REQUEST FOR COUNCIL ACTION

AGENDA SECTION: PUBLIC HEARINGS	ORIGINATING DEPT: PLANNING	ITEM NO. E-3
ITEM DESCRIPTION: Zoning District Amendment #03-05 by the Minnesota Department of Transportation to amend the Floodway and Flood Fringe boundaries and related 100 Year Flood Protection Elevations for a portion of Willow Creek.		PREPARED BY: John Harford, Senior Planner

RE: Floodplain Maps for Conditional Letter of Map Revision (CLOMR) Application
U.S. Highway 63 Reconstruction

PROPOSED FLOODPLAIN MODIFICATION MAP
CLOMR APPLICATION, U.S. HIGHWAY 83
OLMSTED COUNTY, MN

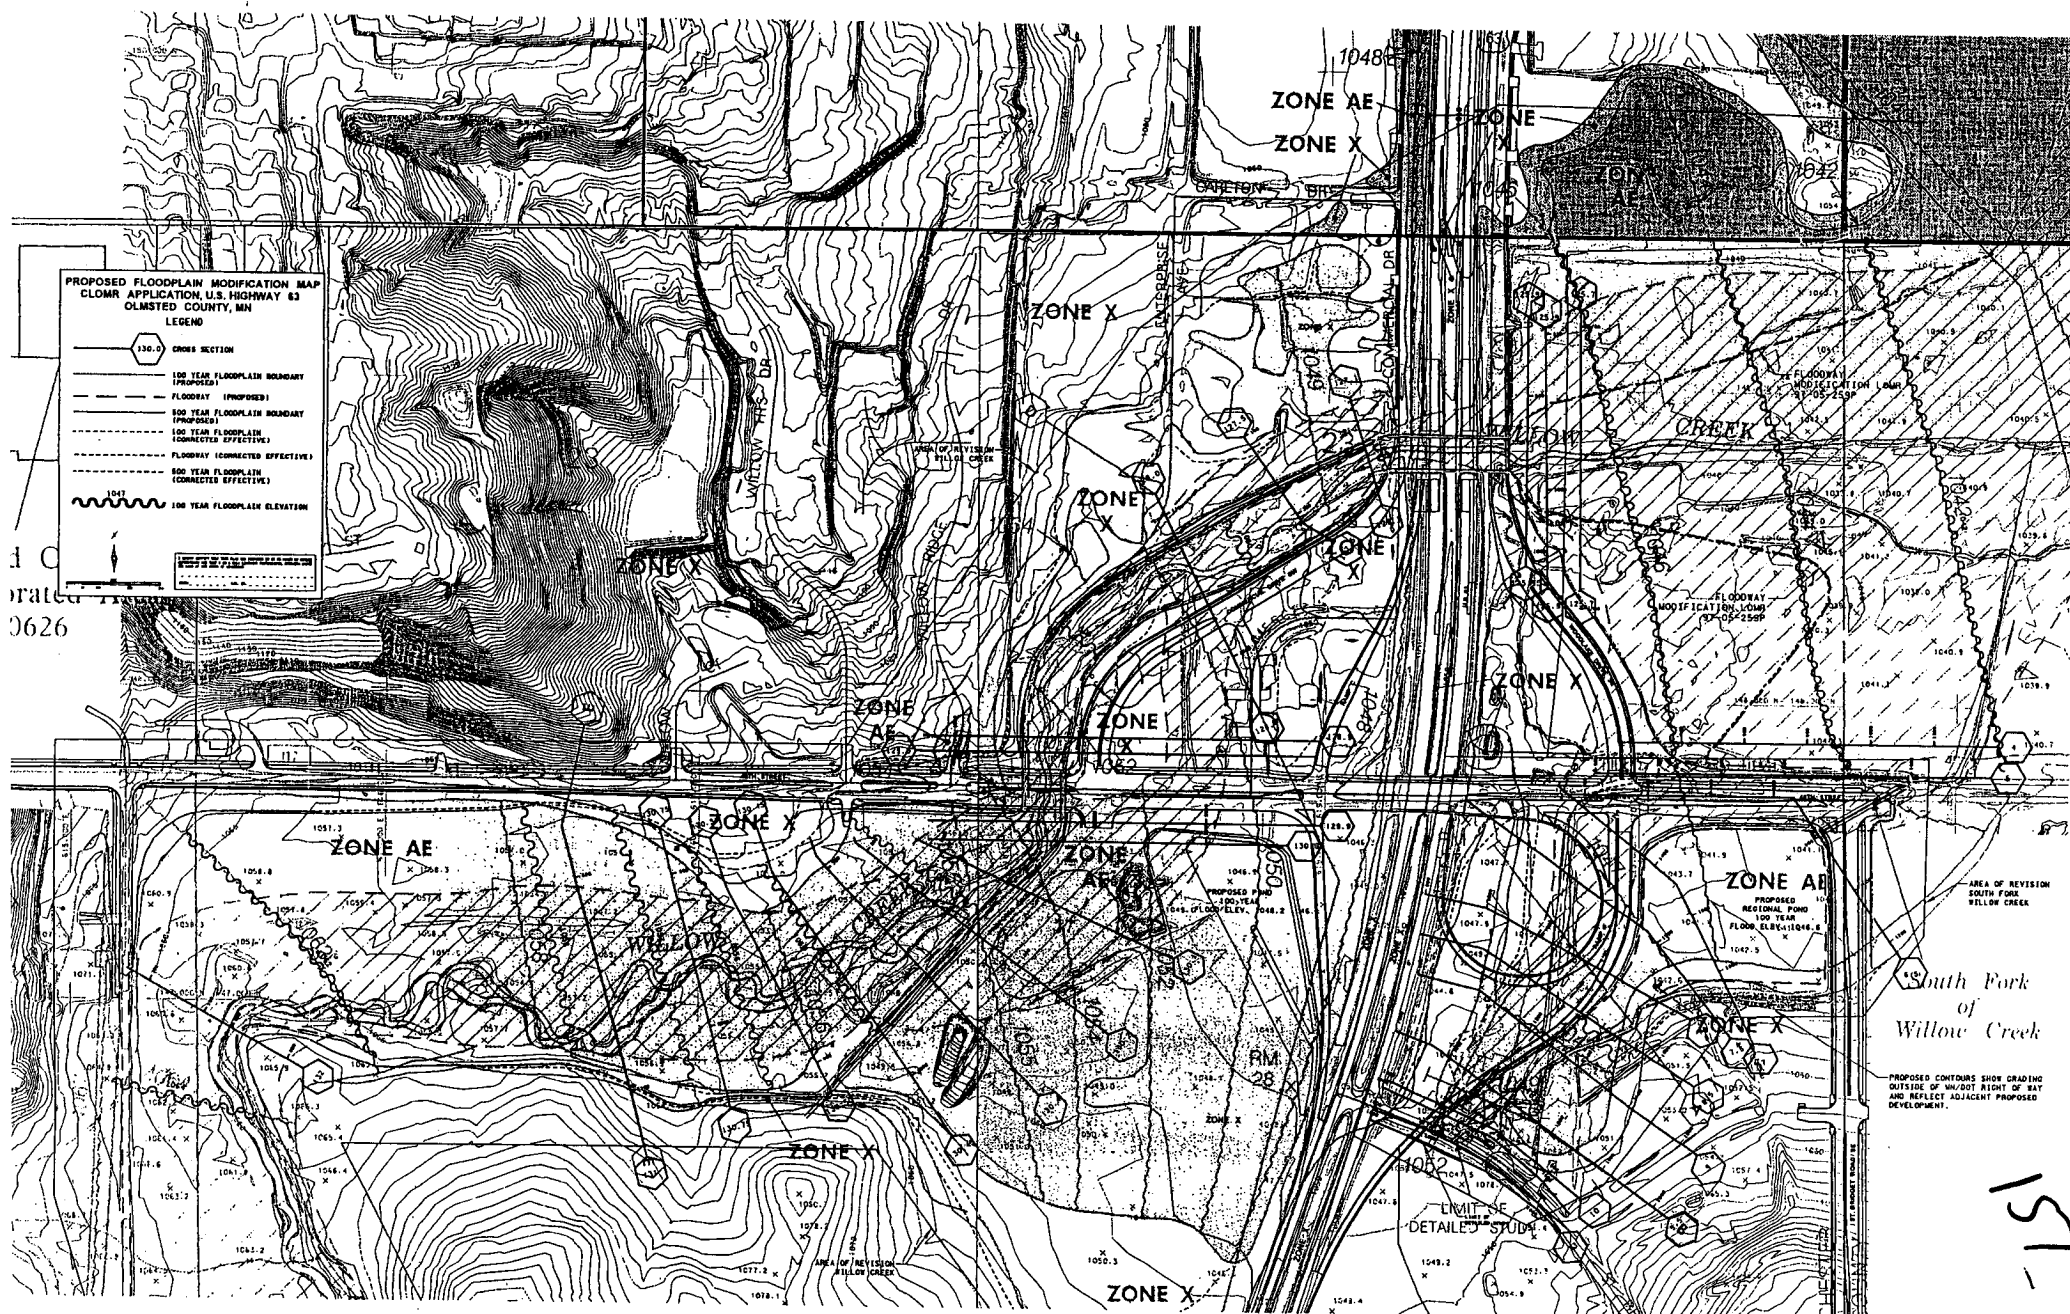
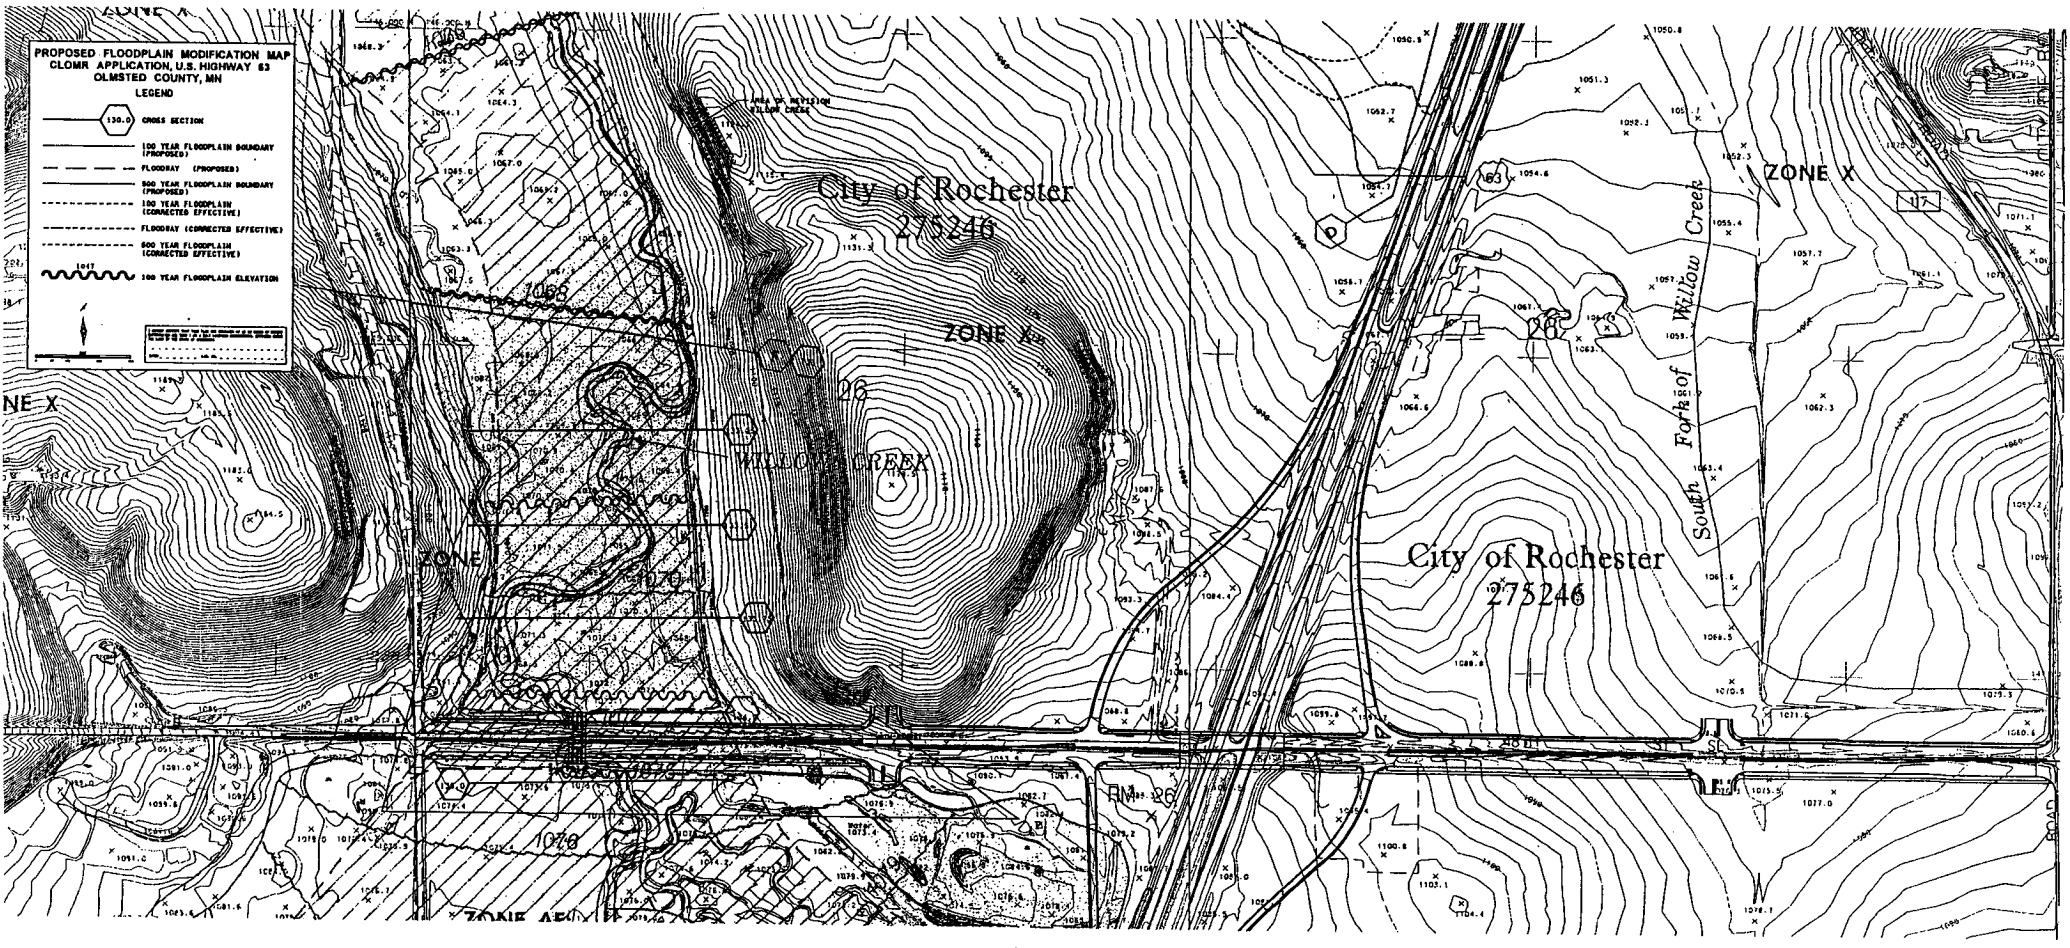
Attached is a copy of the updated floodplain maps that will be submitted to FEMA to illustrate the proposed floodplain and floodway modifications for the U.S Highway 63 Conditional Letter of Map Revision (CLOMR). The maps include an annotated Flood Insurance Rate Map (FIRM) and our topographic work maps. These maps have been changed from the previous maps provided to you in the following ways:

- \$ The floodway modification that was proposed upstream of 48th Street has been eliminated. The floodway will remain as shown on the 1998 FIRM as requested by your March 18, 2003 letter to Art Kalmes.
- \$ The floodplain and floodway for the South Fork of Willow Creek south of the 40th Street extension was modified to reflect recent and proposed grading. The grades shown were based on a drawing provided by Barr Engineering Company as requested by Tom Hexum at the March Planning Commission public hearing.
- \$ Several other minor changes to the maps were made as requested by FEMA. These changes included modifying the floodplain to more accurately reflect proposed grading, showing the location of all modeled cross-sections, and extending the maps to the north to tie into the mapped floodplain.

Map represents
Panels 302, 303, 304
FIRM dated
Feb., 1998 and April, 1995

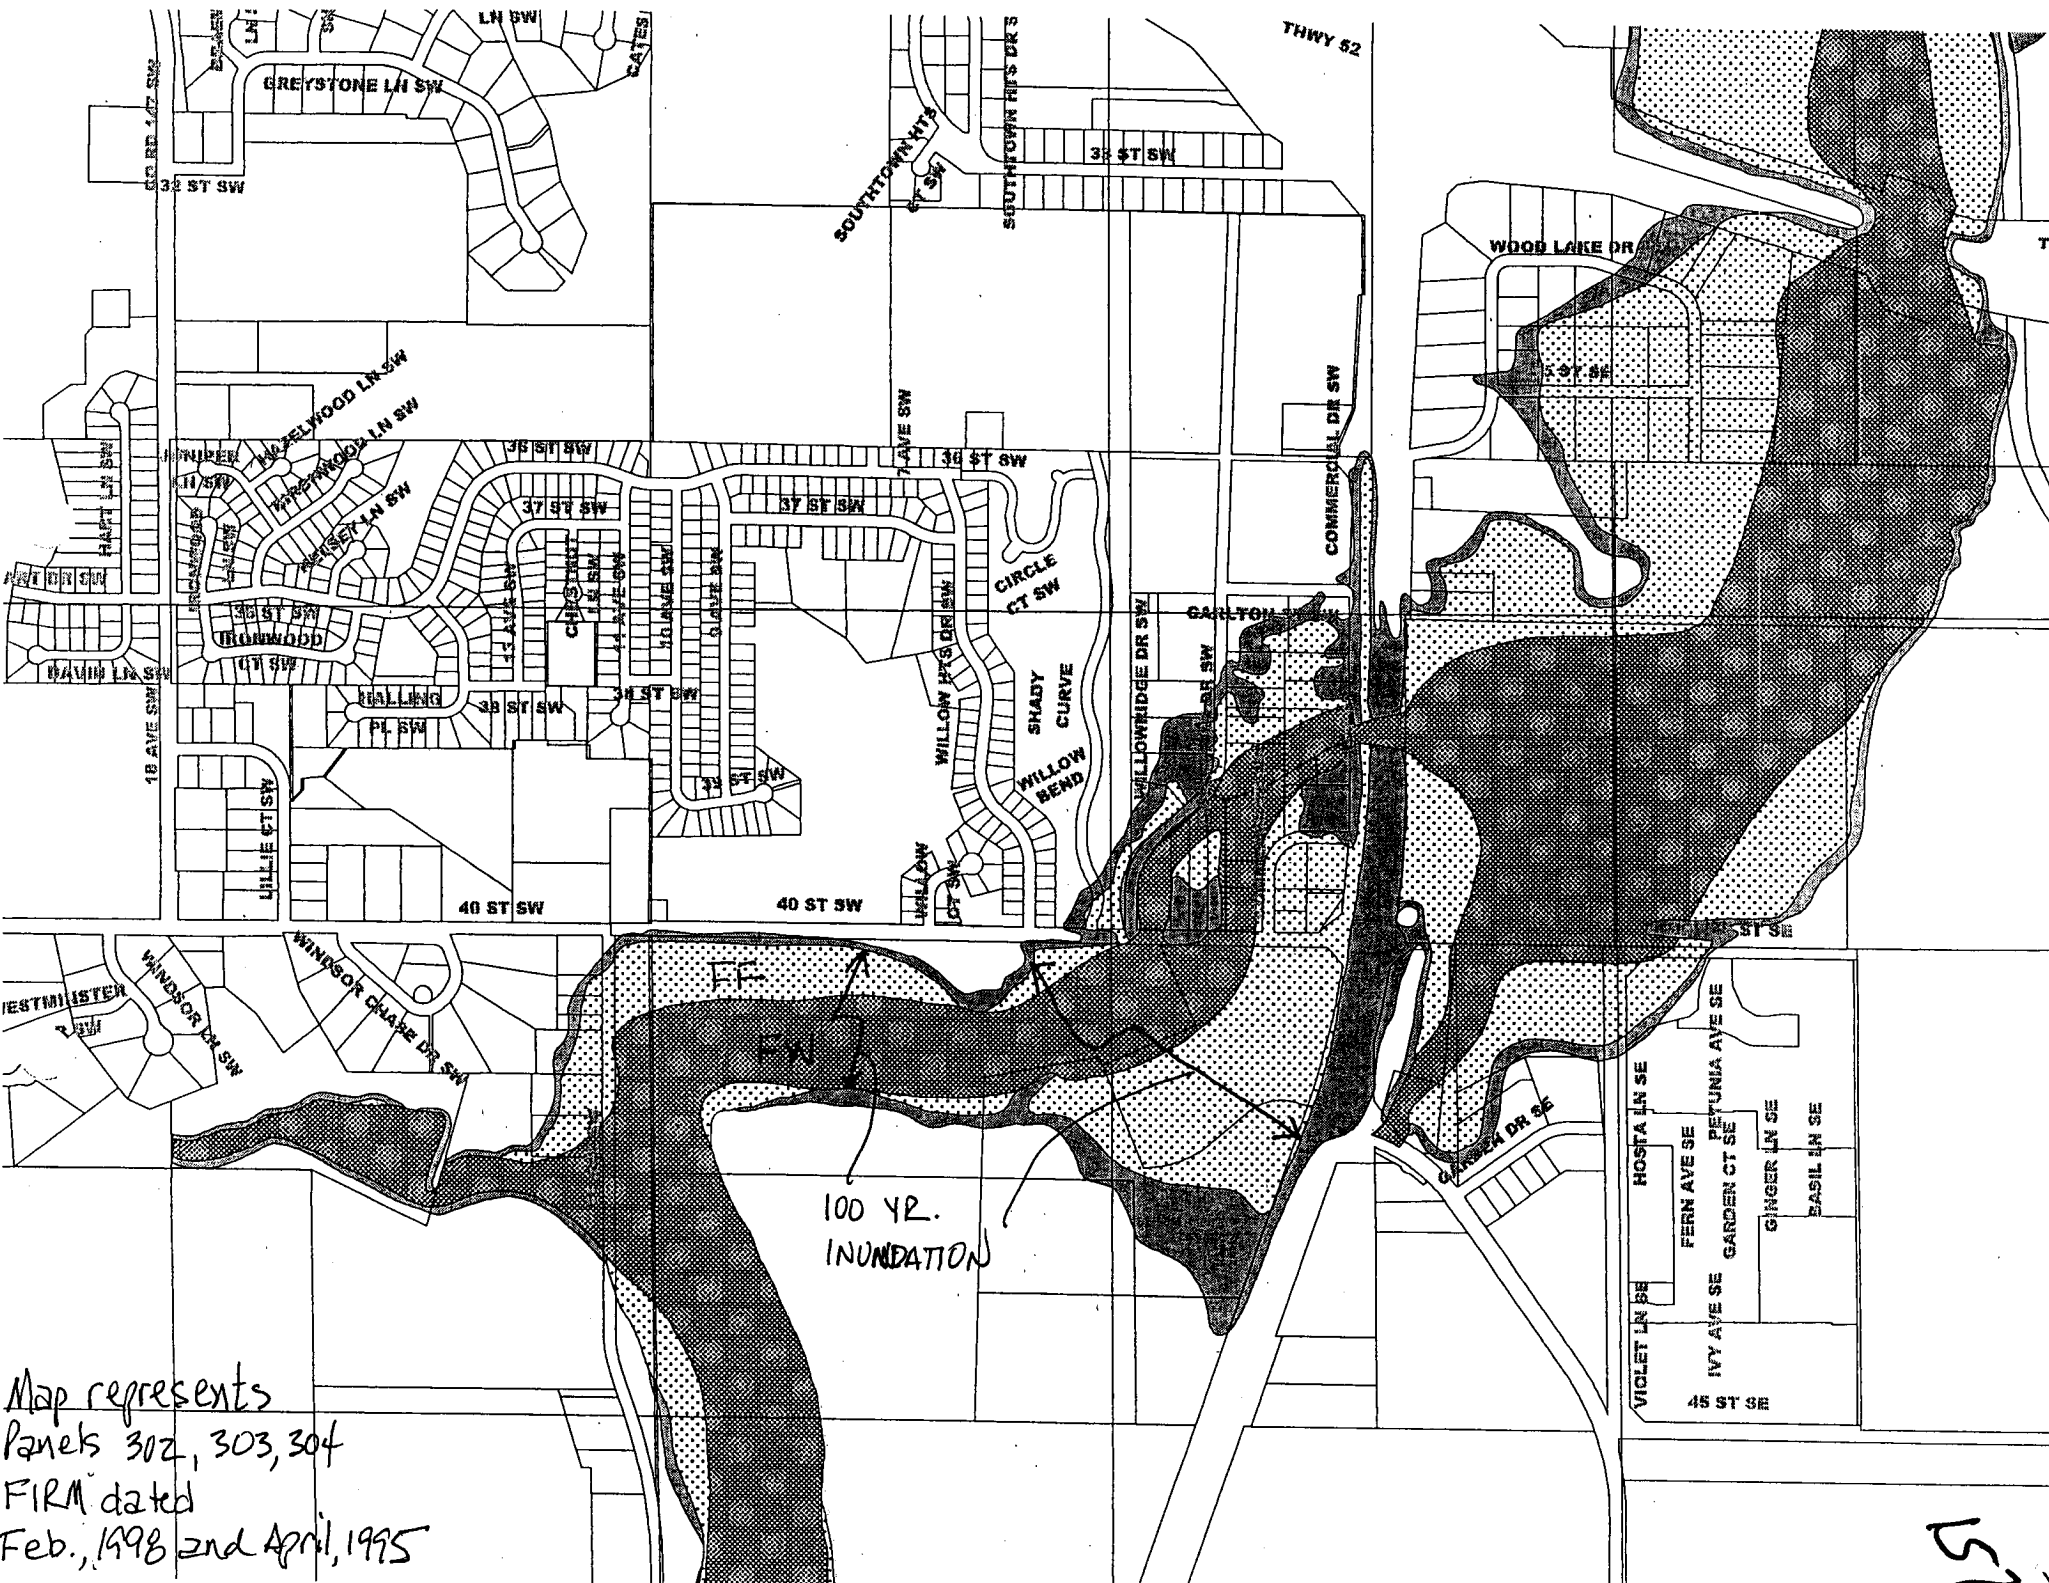
During the city review process, however, city staff indicated their concern over the amendment to the MNDOT proposed Floodway boundary in the area south of 48th St., SW. This segment of Willow Creek is immediately downstream of the Flood Control Structure WR-6A. The city staff believes it is necessary in this area to preserve the limits established in the 1998 FIRM as a measure of safety in the case of large storm events that would result in a release of stormwater through the overflow spillway and in the case of a catastrophic failure of the Flood Control Structure.

The City staff recommends that MNDOT agree to withdraw the amendment as proposed on that portion of the Floodway boundary south of 48th St., SW based on the City's concern for the protection of the public safety and welfare. The City Council will consider this application in about one month and will determine at that time if the Floodway should be amended as you propose in the application or to keep the Floodway boundaries as they appear in the 1998 FIRM. Also, given the staff recommendation the city will withhold signing the Community Acknowledgement Letter until the City Council adopts a resolution approving the proposal.
